FOUNDATION INVESTIGATION REPORT

W.P. 40-66-08/09
Hwy. 402, District 2
Concession 3 Road Overpass (EBL/WBL)
2.6 Miles West of Hwy. 2

REVIEW OF DESIGN DRAWINGS:

Subject: REVISED FOUNDATION RECOMMENDATIONS
FOR

BORE HOLE LOCATIONS & SOIL STRATA

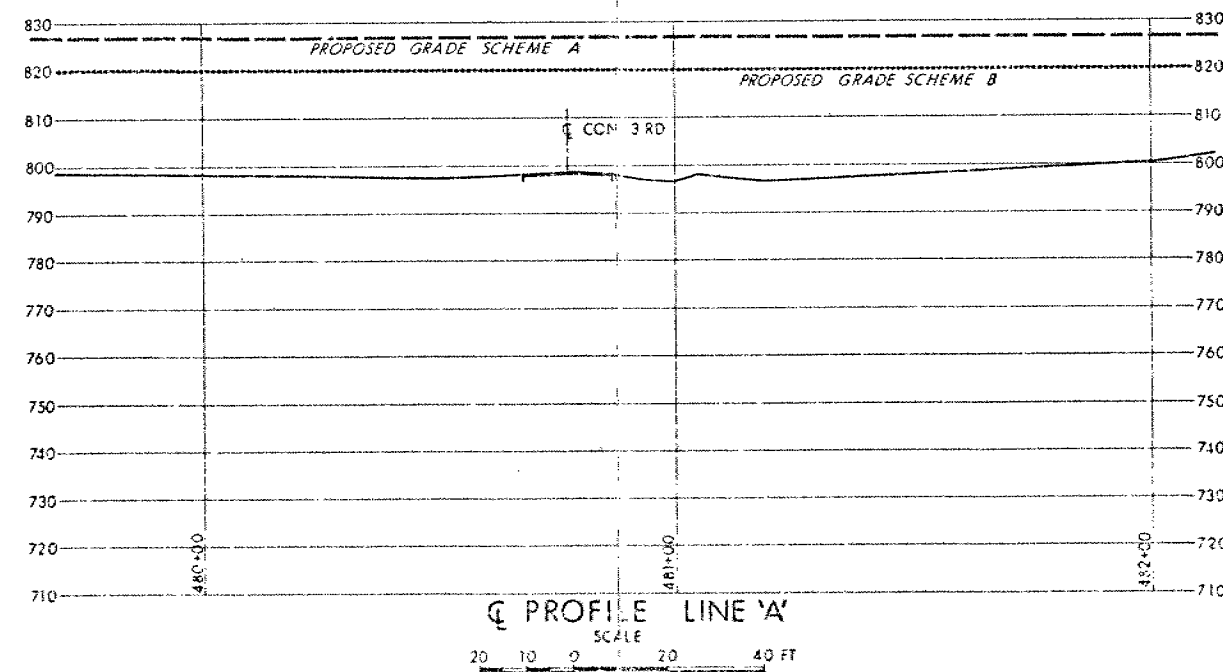
1. Does footing design comply with our report or subsequent memos? YES
2. If answer to 1. is No, is present design acceptable? N/A
3. Has sufficient field work been done? N/A
4. Are estimated pile lengths shown on Drawings correct? If not, make a new list. N/A
5. If excavation of unsuitable soil is recommended, is this shown on Drawings? N/A
6. Are approaches designed in accordance with our report? Check slopes and berm lengths. YES
7. Do you anticipate any construction problems? i.e., dewatering, stability of temporary slopes or excavations.
8. Summarize your comments; on separate sheet if necessary.

A DEWATERING SCHEME WILL BE REQUIRED FOR THE FOOTING (PIER) EXCAVATIONS
